CHANGE ORDER

Project: Benner Twp

Change Order No.: 3

**BENNER TOWNSHIP PFAS INVESTIGATION
REQUISITION NUMBER GTAC7-4-106
Change Order 03
WORK PLAN/COST ESTIMATE**

Proposed Background Sampling Locations

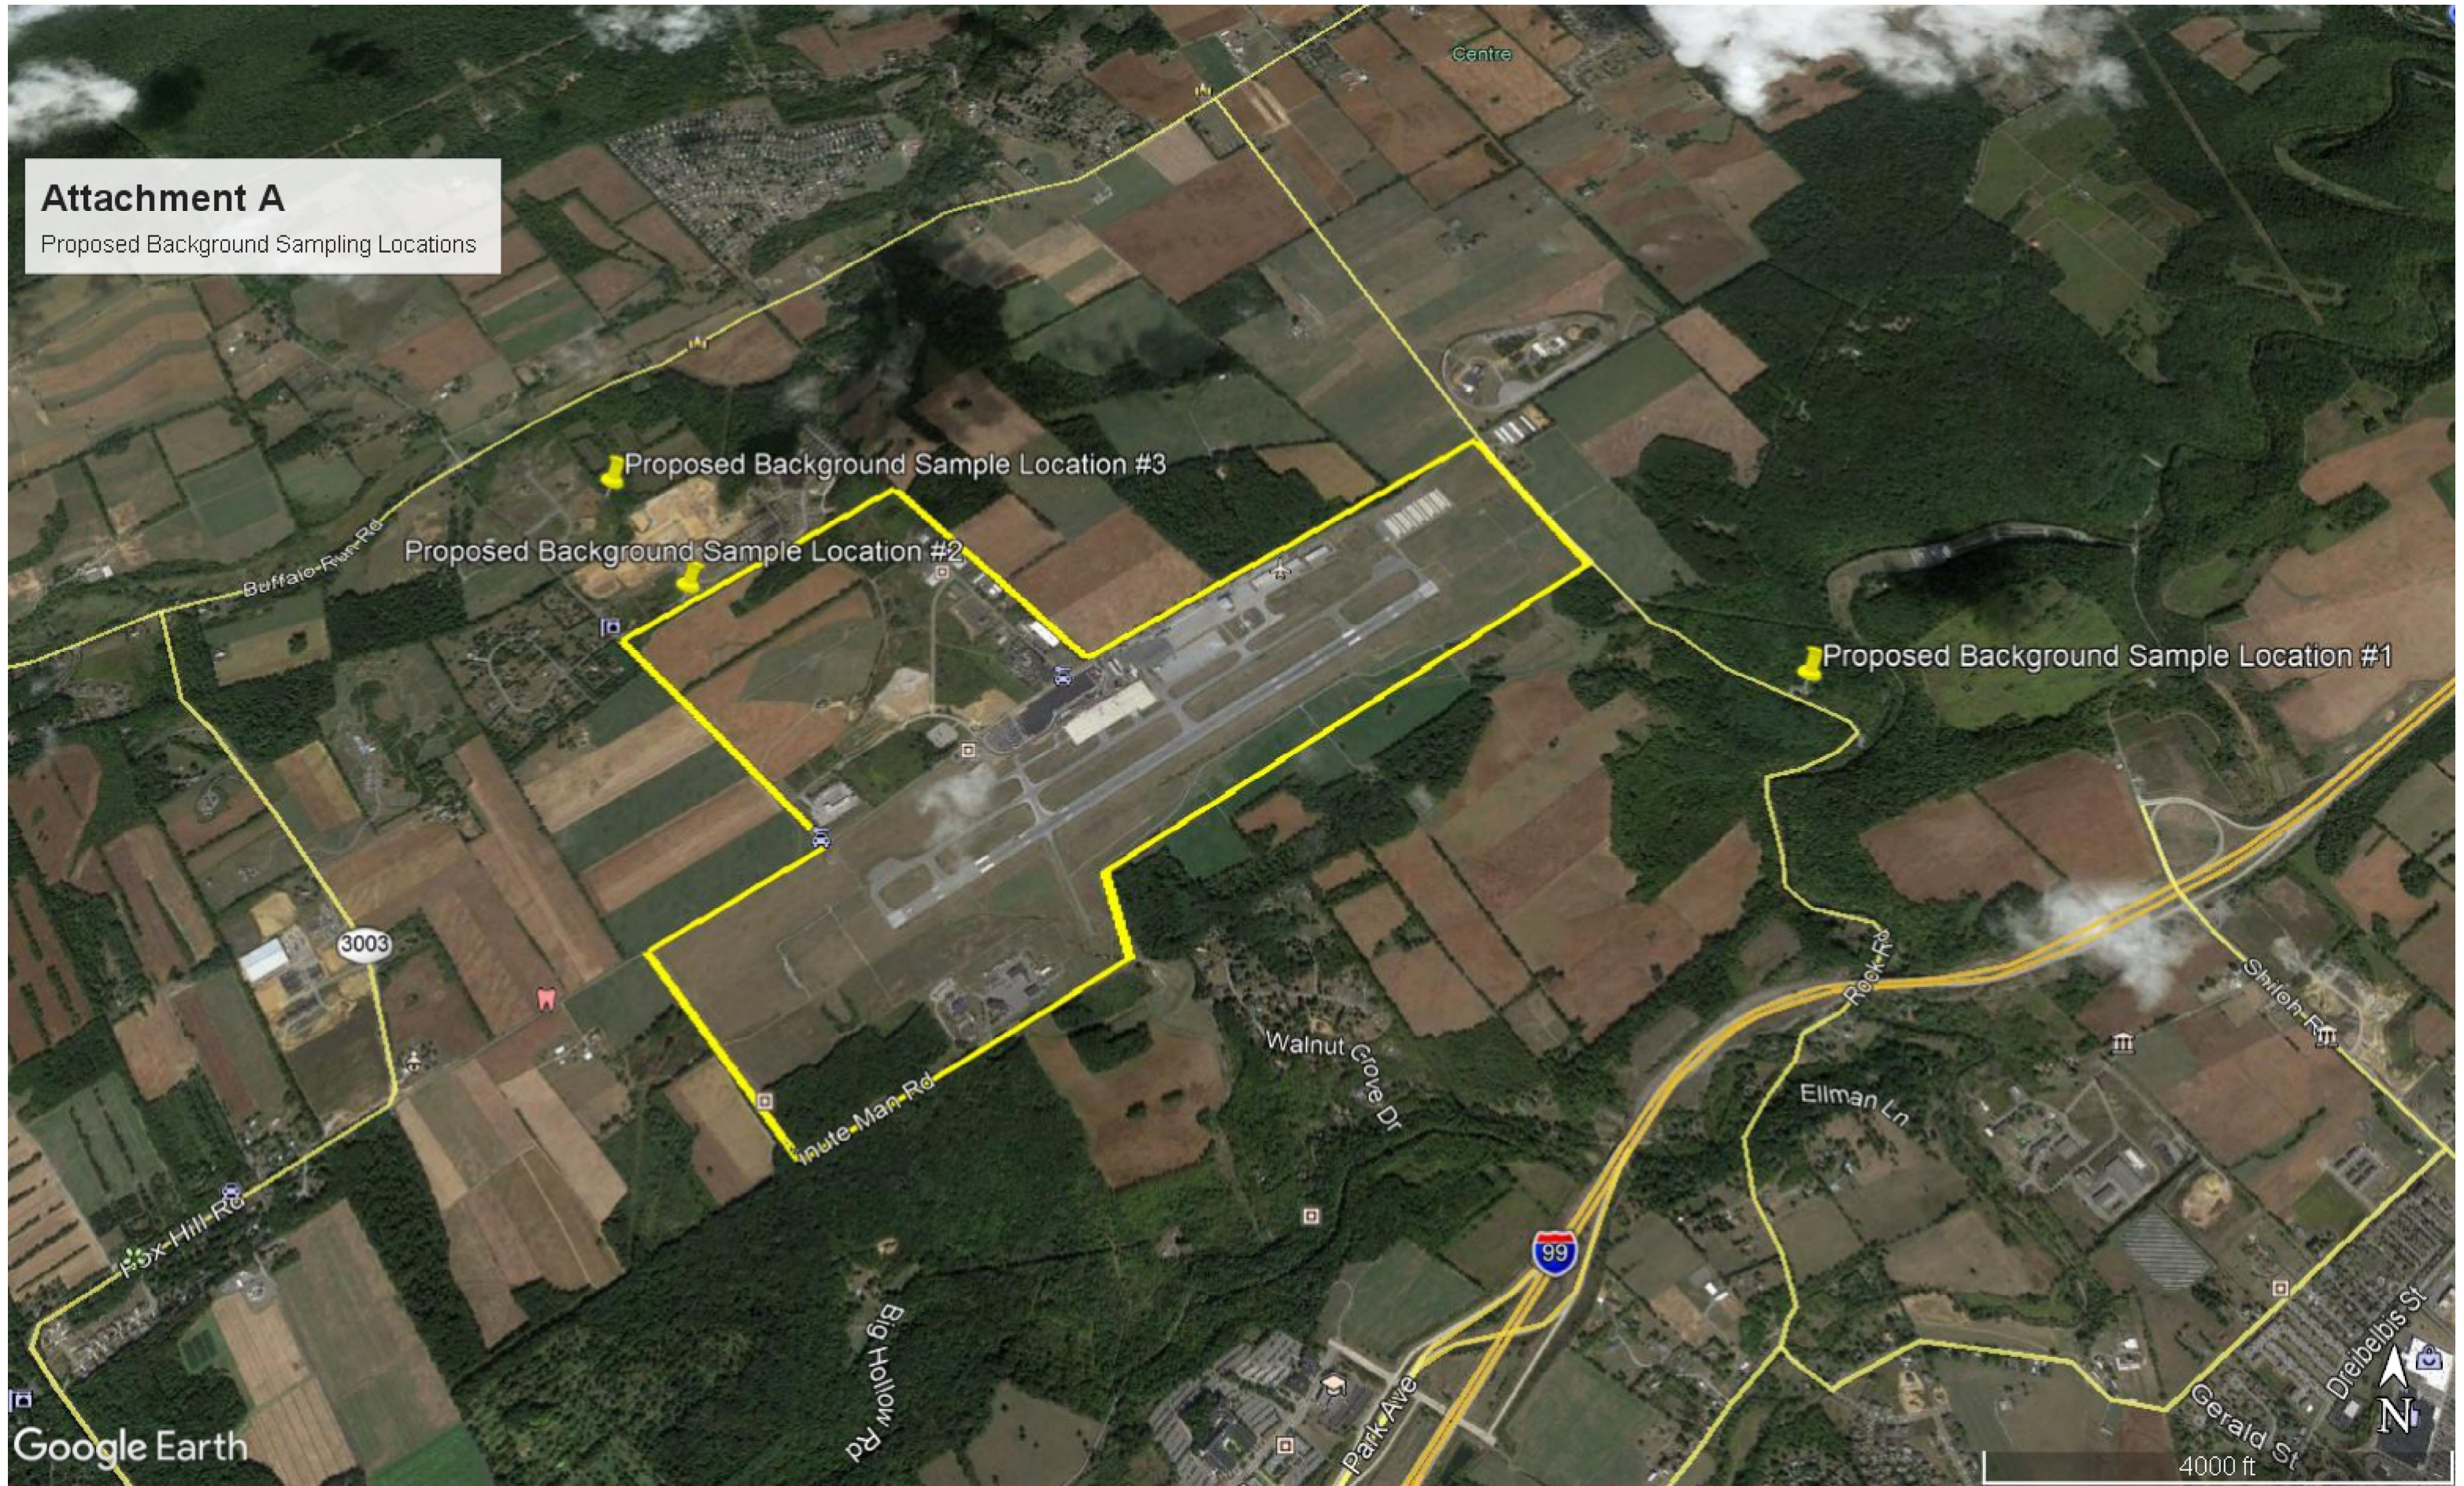
HDR proposes to install up two (2) soil borings and collect up to two (2) soil samples from a background site to compare to PFAS-impacted sites (areas where AFFF was used for firefighting training and other potential source areas related to manufacturing operations). There are three (3) proposed background sites located in Benner Township including a gravel parking lot at 1025 Rock Road (Location 1); an undeveloped area/gravel road near Fulton's Run Road (Location 2); and an undeveloped lot near Far Hills Avenue (Location 3). The proposed locations are presented in Attachment A. Permission to access this area will be needed prior to installing the soil boring and collecting the samples.

FIGURE 10
PROPOSED SOIL SAMPLE LOCATIONS
BENNER TWP PFAS SITE

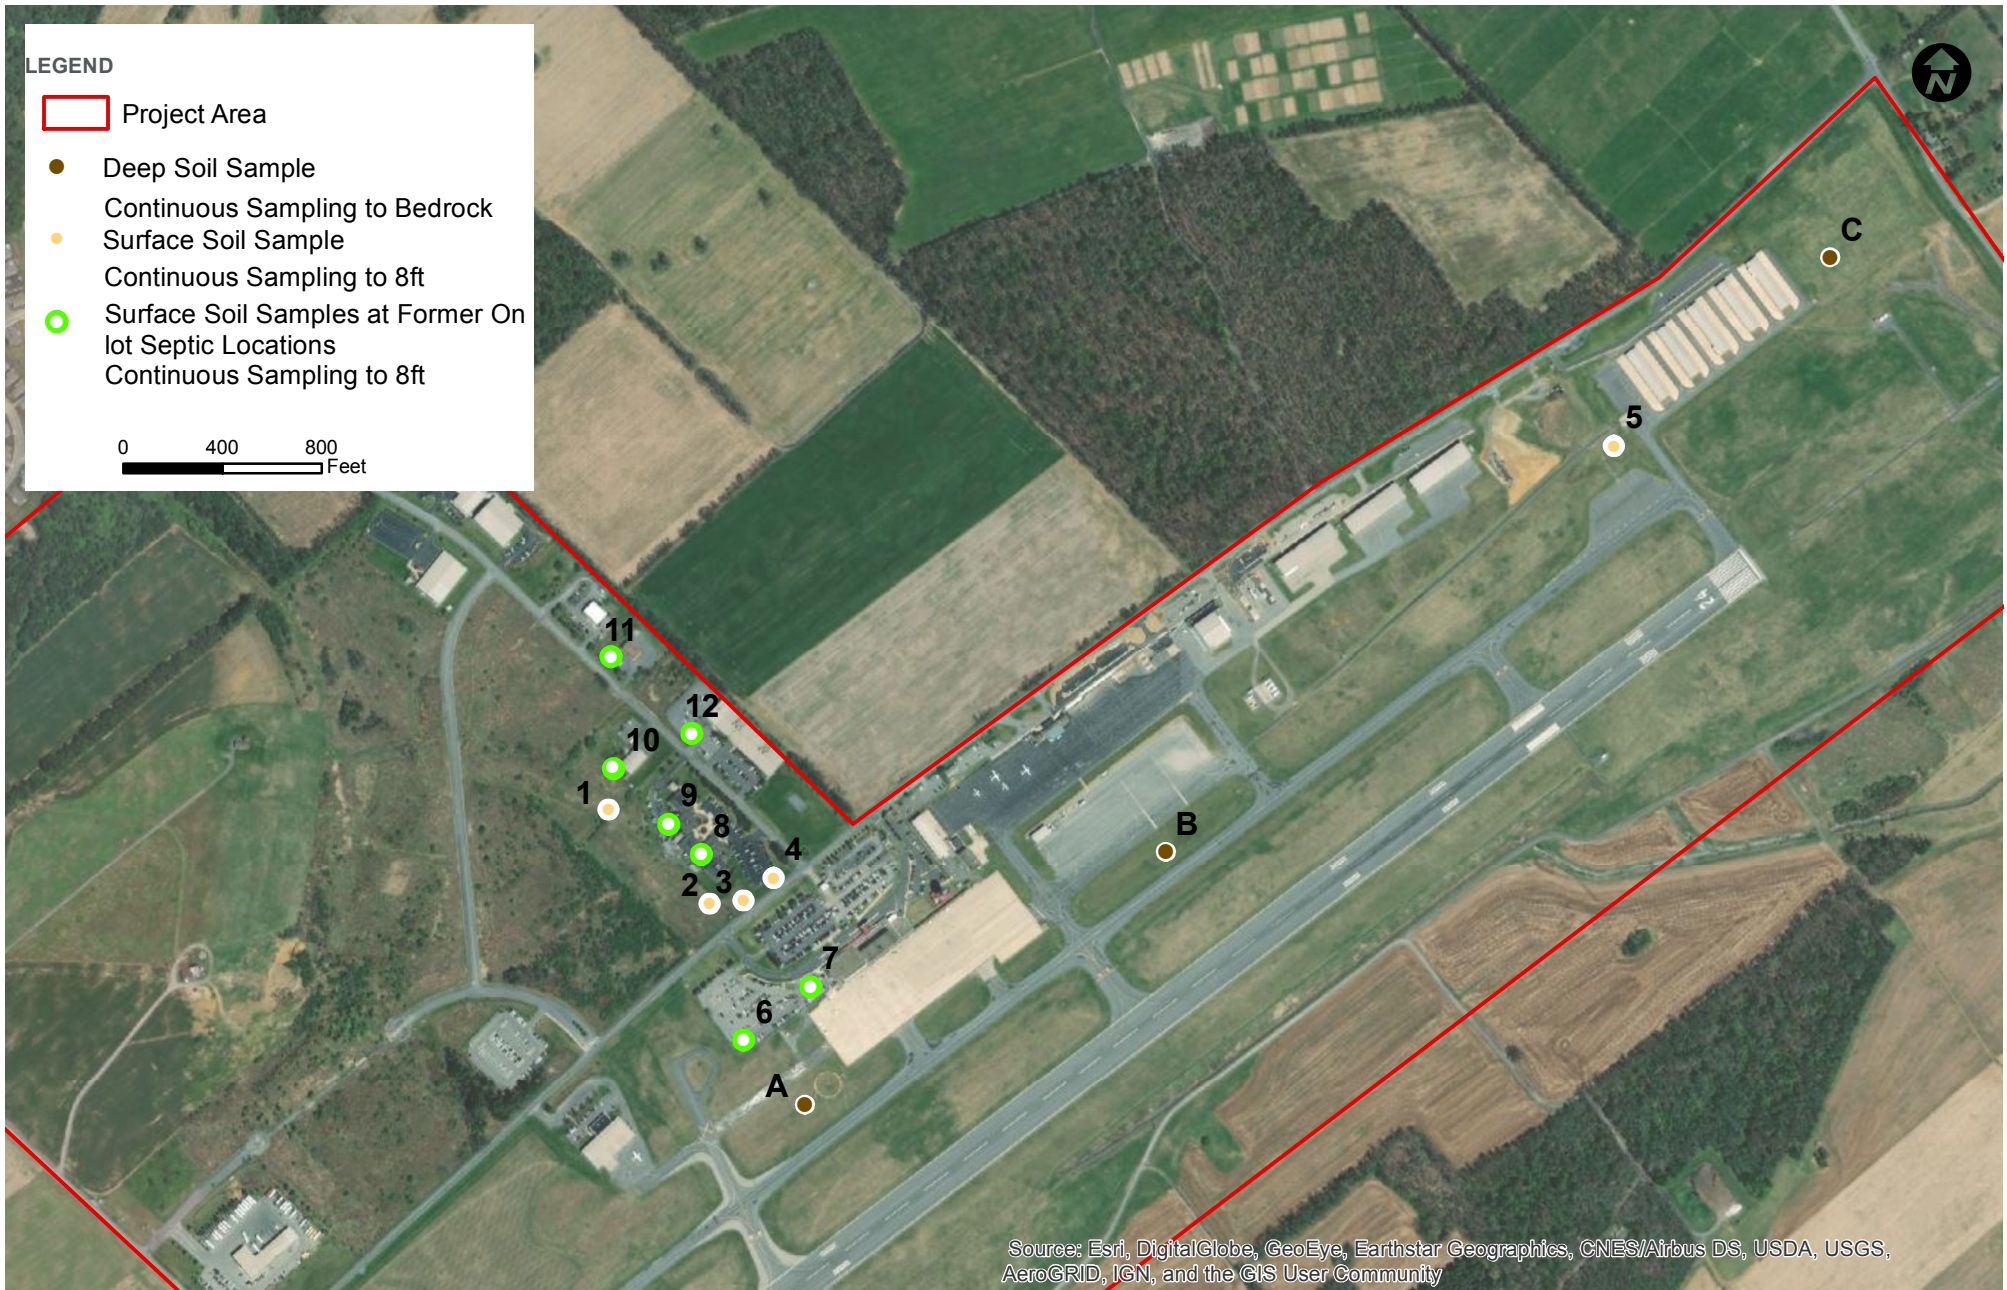
HDR proposes to install nine (9) soil borings and collect up to two (2) soil samples per boring to characterize PFAS contamination from historical releases of AFFF or for other potential PFAS sources. The soil-boring locations are located on the following properties located on Fox Hill Road and High Tech Road. The proposed soil boring locations are presented in Attachment B and as follows:

- Six (6) borings at the State of the Art Property located at 2470 Fox Hill Road, State College, PA including:
 - One (1) boring at the former septic tank
 - One (1) boring at the former drain field
 - One (1) boring near the stormwater outflow
 - One (1) boring near the area of the repaired sinkhole
 - One (1) boring near stormwater runoff to the stormwater inlet
 - One (1) boring upgradient of the stormwater inlet
- One (1) boring at Matreya, LLC located at 2178 High Tech Road, State College, PA to characterize the former septic system.
- One (1) boring at Cannon Instruments, Inc. located at 2139 High Tech Road, State College, PA to characterize the former septic system.
- One (1) boring at Enterprise Rental Car located at 2175 High Tech Road, State College, PA to characterize the former septic system.

A total of six (6) soil boring locations are proposed on the UPA property and up to two (2) soil samples per boring. A surface soil sample will be collected from the 0 to 2' bgs interval and a subsurface soil sample will be collected at refusal or approximately 20' bgs, whichever is encountered first. According to the PADEP, PSU will install these borings and collect the soil samples. Three (3) borings are proposed in three (3) areas of known discharge of AFFF (presented in Attachment B) to the ground and described below:

- One (1) boring at ARFF Area 4 (AFFF discharged to pavement and a grass during the 2009 ARFF training event)
- One (1) boring at ARFF Area 3 (AFFF discharged to grass prior to 2006 during ARFF training events)
- One (1) boring at ARFF Area 1 (AFFF discharged to grass prior to 2006 during ARFF training events)

In addition, three (3) borings are proposed on UPA property for sampling to characterize soils impacted from stormwater runoff and potential releases of AFFF to the 50,000 gallon deicing tank and the former on-lot septic system that existed before the airport connected to the public sewer system. The location of three (3) borings is presented Attachment B and described below:

- One (1) boring near the 50,000 gallon deicing tank for the potential overflow of AFFF
- One (1) boring near the former septic drain field
- One (1) boring near the former septic tanks
